# Access Compliance Report

## Public Rights-of-Way

Intersection ID: 32300	Main Street: AUBURN_TOP_LN	Cross Street: HAZELVIEW_DR	Location: NW
ADA ID: C397E3D59BD0	Ramp Type: PerpDiag	Initial Pass/Fail: Fail	Overall Compliance: No
		Severity Score: 37.5

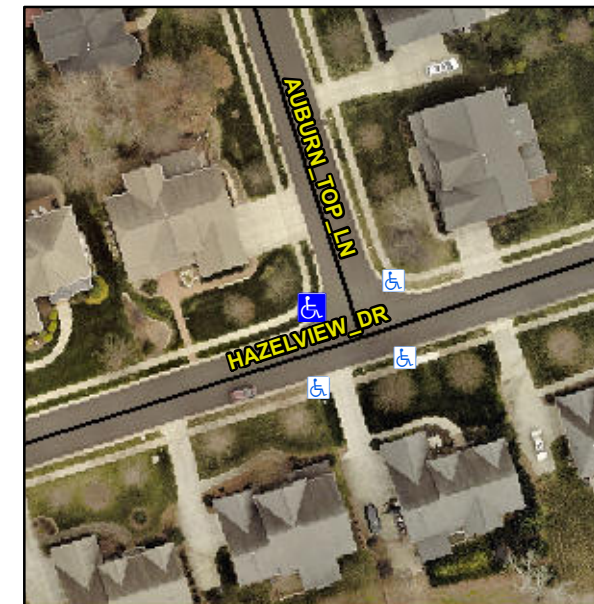
**Not Found, R304.2.2, R304.5.3**

Compliance	Description	Data	Compliance	Description	Data
N/A	Ramp Length (in)	101.0	No	Ramp Slope (%)	8.5
Yes	Ramp Width (in)	48.0	No	Ramp XSlope (%)	14.0
N/A	Flare Type LT	N/A	N/A	Flare Type RT	N/A
N/A	Flare Slope LT (%)	N/A	N/A	Flare Slope RT (%)	N/A
N/A	Flare Traversable LT?	N/A	N/A	Flare Traversable RT?	N/A
N/A	Landing Length (in)	N/A	N/A	DWS Provided?	N/A
N/A	Landing Width (in)	N/A	N/A	DWS Contrast?	N/A
N/A	Landing Slope (%)	N/A	N/A	DWS Length (in)	N/A
N/A	Landing X Slope (%)	N/A	N/A	DWS Full Width?	N/A
N/A	Landing Curb? (Y/N)	N/A	N/A	DWS Offset (in)	N/A
N/A	Shared Landing?	N/A			
N/A	Gutter Ponding?	N/A	N/A	Gutter Slope (%)	N/A
N/A	Gutter Lip Ht (in)	N/A	N/A	Gutter X Slope (%)	N/A
N/A	Painted X Walk1?	No	N/A	Painted X Walk2?	No
	X Walk 1 Direction	To E		X Walk 2 Direction	To S
N/A	X Walk 1 Width (in)	N/A	N/A	X Walk 2 Width (in)	N/A
	X Walk 1 Slope (%)	6.4		X Walk 2 Slope (%)	4.8
	X Walk 1 X Slope (%)	7.0		X Walk 2 X Slope (%)	6.1

**Remove & Replace Curb Ramp With Two New Directional Ramps or Equivalent.**
